Access Compliance Report

Public Rights-of-Way

Intersection ID: 44925	Main Street: TWIN_BROOK_DR	Cross Street: MINTVALE_DR	Location: SE
ADA ID: B6A0CF43954B	Ramp Type: Perp	Initial Pass/Fail: Fail	Overall Compliance: No
Severity Score: 33.75			
Codes/Mitigation Info/Possible Solution		Field Measurements/Component Compliance

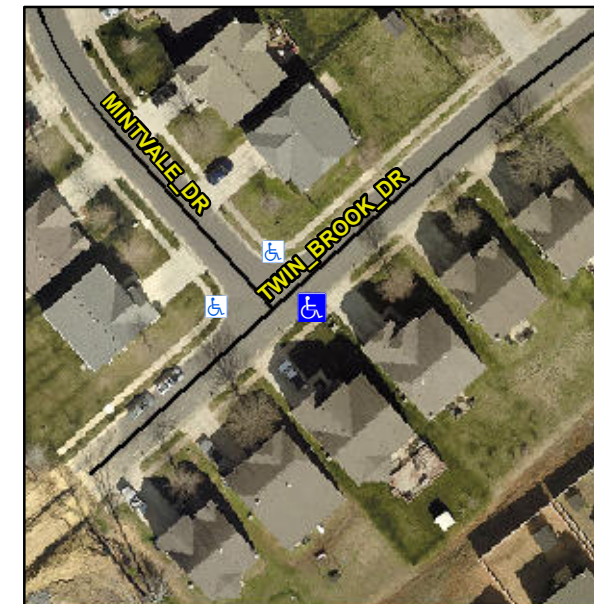
Not Found, R304.5.1, R304.2.2

Compliance	Description	Data	Compliance	Description	Data
N/A	Ramp Length (in)	47.0	No	Ramp Slope (%)	15.5
No	Ramp Width (in)	47.5	Yes	Ramp XSlope (%)	0.2
N/A	Flare Type LT	N/A	N/A	Flare Type RT	N/A
N/A	Flare Slope LT (%)	N/A	N/A	Flare Slope RT (%)	N/A
N/A	Flare Traversable LT?	N/A	N/A	Flare Traversable RT?	N/A
N/A	Landing Length (in)	N/A	N/A	DWS Provided?	N/A
N/A	Landing Width (in)	N/A	N/A	DWS Contrast?	N/A
N/A	Landing Slope (%)	N/A	N/A	DWS Length (in)	N/A
N/A	Landing X Slope (%)	N/A	N/A	DWS Full Width?	N/A
N/A	Landing Curb? (Y/N)	N/A	N/A	DWS Offset (in)	N/A
N/A	Shared Landing?	N/A			
N/A	Gutter Ponding?	N/A	N/A	Gutter Slope (%)	N/A
N/A	Gutter Lip Ht (in)	N/A	N/A	Gutter X Slope (%)	N/A
N/A	Painted X Walk1?	No	N/A	Painted X Walk2?	N/A
	X Walk 1 Direction	To NW		X Walk 2 Direction	N/A
N/A	X Walk 1 Width (in)	N/A	N/A	X Walk 2 Width (in)	N/A
	X Walk 1 Slope (%)	3.6		X Walk 2 Slope (%)	N/A
	X Walk 1 X Slope (%)	0.7		X Walk 2 X Slope (%)	N/A

Remove & Replace Entire Ramp.
